Access Compliance Report

Public Rights-of-Way

Intersection ID: 12347	Main Street: S_CHURCH_ST	Cross Street: W_3RD_ST	Location: W
ADA ID: 624DE83349B9	Ramp Type: BlendTrans1	Initial Pass/Fail: Fail	Overall Compliance: No
		Severity Score: 12.5

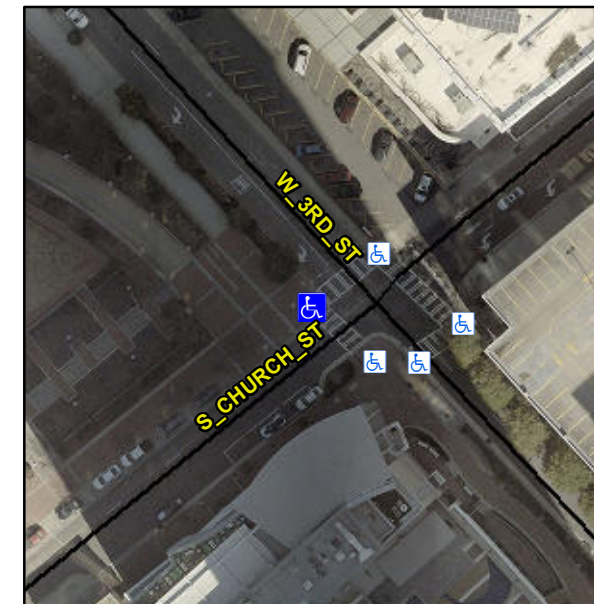
R304.5.3

Compliance	Description	Data	Compliance	Description	Data
N/A	Ramp Length (in)	64.0	Yes	BlendTrans Slope (%)	3.4
Yes	Ramp Width (in)	115.0	No	BlendTrans XSlope (%)	6.9
N/A	Flare Type LT	N/A	N/A	Flare Type RT	N/A
N/A	Flare Slope LT (%)	N/A	N/A	Flare Slope RT (%)	N/A
N/A	Flare Traversable LT?	N/A	N/A	Flare Traversable RT?	N/A
N/A	Landing Length (in)	N/A	N/A	DWS Provided?	N/A
N/A	Landing Width (in)	N/A	N/A	DWS Contrast?	N/A
N/A	Landing Slope (%)	N/A	N/A	DWS Length (in)	N/A
N/A	Landing X Slope (%)	N/A	N/A	DWS Full Width?	N/A
N/A	Landing Curb? (Y/N)	N/A	N/A	DWS Offset (in)	N/A
N/A	Shared Landing?	N/A			
N/A	Gutter Ponding?	N/A	N/A	Gutter Slope (%)	N/A
N/A	Gutter Lip Ht (in)	N/A	N/A	Gutter X Slope (%)	N/A
N/A	Painted X Walk1?	Yes	N/A	Painted X Walk2?	Yes
	X Walk 1 Direction	To SE		X Walk 2 Direction	To NE
	X Walk 1 Width (in)	104.0		X Walk 2 Width (in)	111.0
	X Walk 1 Slope (%)	8.4		X Walk 2 Slope (%)	4.6
	X Walk 1 X Slope (%)	2.4		X Walk 2 X Slope (%)	11.3

Remove & Replace Curb Ramp With Two New Directional Ramps or Equivalent.
